**REQUEST FOR BIDS
Pedestrian Bridges and
Concrete Footings for
Bus Stops
TO-22-05**

**ADDENDUM NO. 3
TO
PLANS AND SPECIFICATIONS
FOR**

**NE SEWARD AVENUE BULB-OUT PROJECT -
NE SEWARD AVE FROM NE LAKE ST TO NE GRATTAN ST
CITY OF TOPEKA, KANSAS**

Project No. T-501023.15 & T-501081.01

G-02R

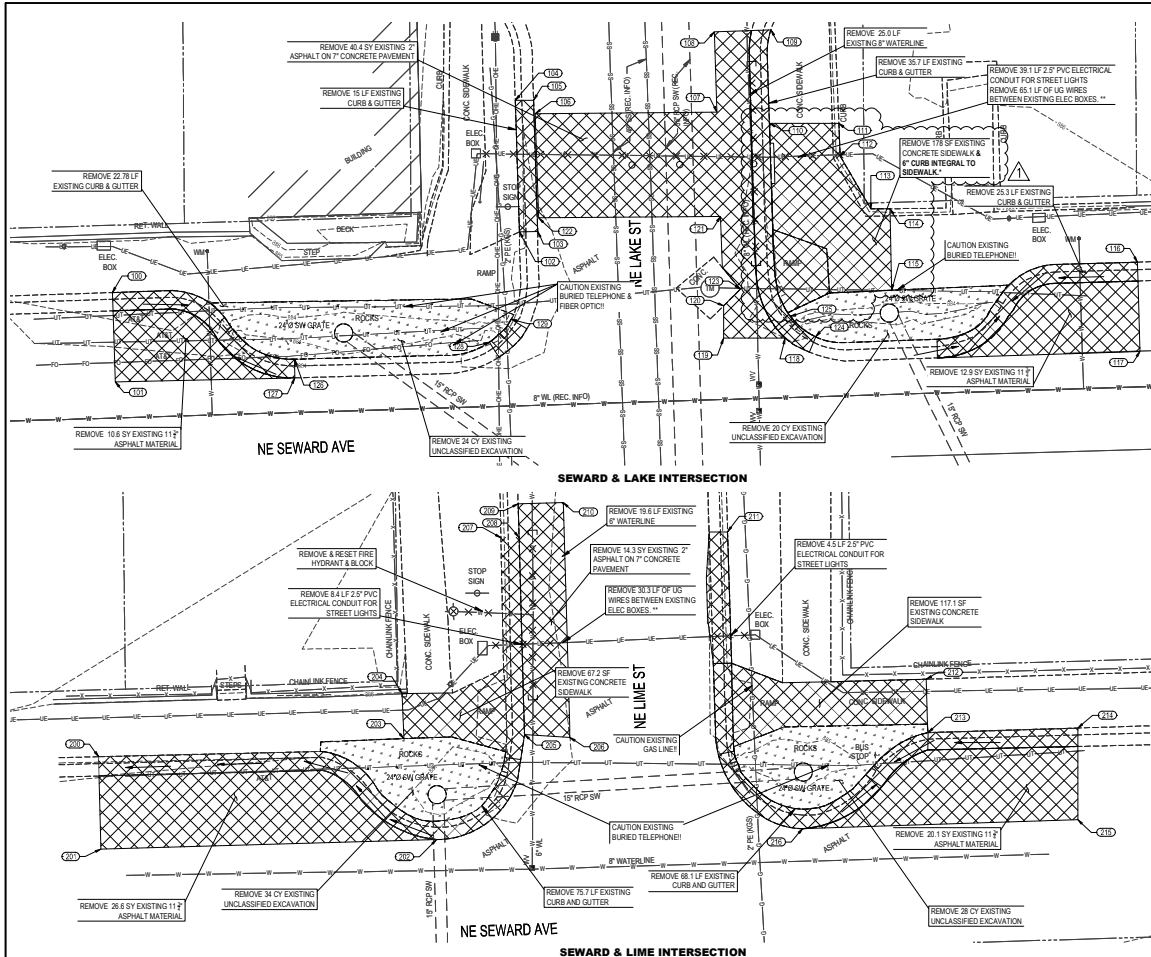
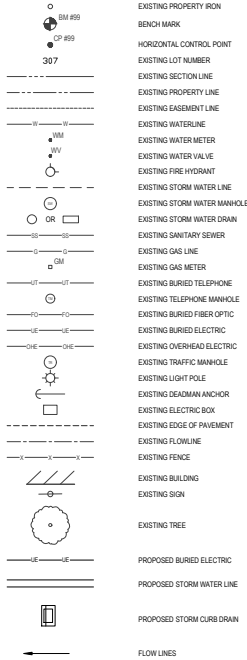
ITEM NO. 1 **SHEET NO. G-02 – NOTES, SUMMARY OF QUANTITIES, ABBREVIATIONS, & LEGEND**

DELETE this plan sheet in its entirety and **REPLACE** with the attached Plan Sheet **G-02R – NOTES, SUMMARY OF QUANTITIES, & ABBREVIATIONS.**

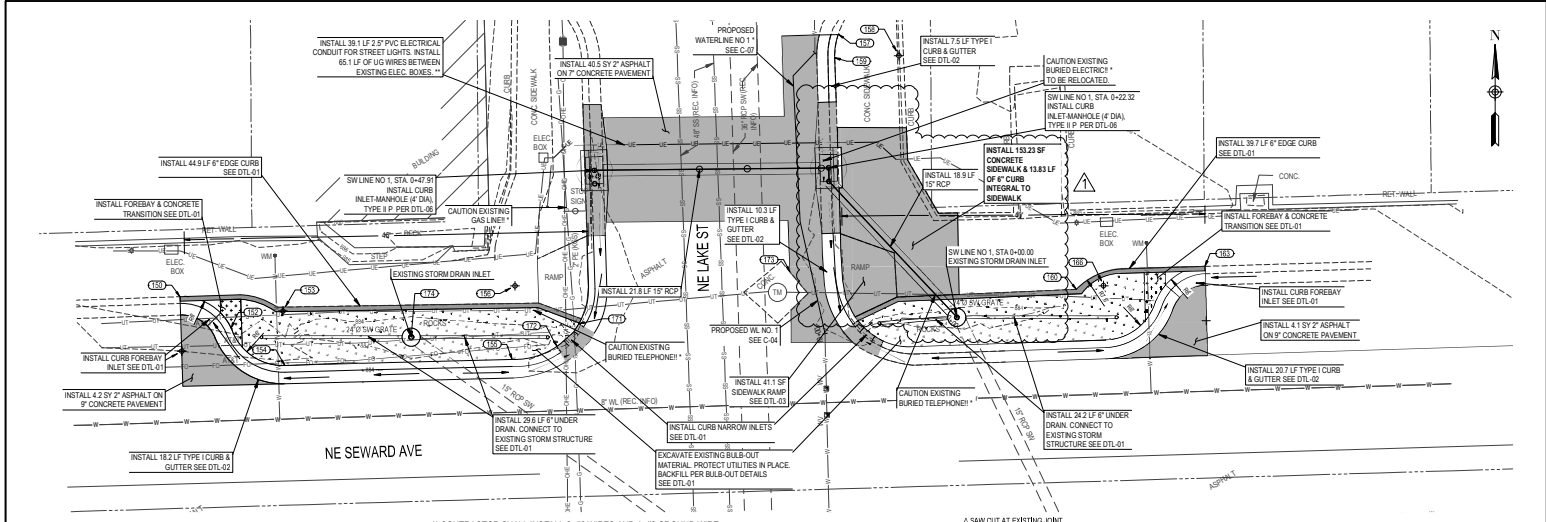
DELETE this plan sheet in its entirety and **REPLACE** with the attached Plan Sheet **D-01R – DEMO PLAN**. The revision includes removing the 6” curb that is integral to the sidewalk to be removed.

*CURB REMOVAL SHALL BE CONSIDERED SUBSIDIARY TO THE SIDEWALK REMOVAL

DATE: 06/20/21
PROJECT: T-501023.15 / T-501081.01
SHEET: 09 OF 41
C-01R

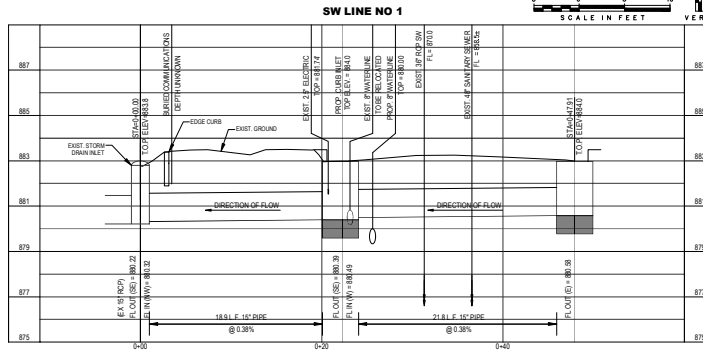
DELETE this plan sheet in its entirety and **REPLACE** with the attached Plan Sheet **C-01R – PLAN AND PROFILE**. The revision includes replacing the small sod area with concrete sidewalk and adding the 6” curb integral to the sidewalk.
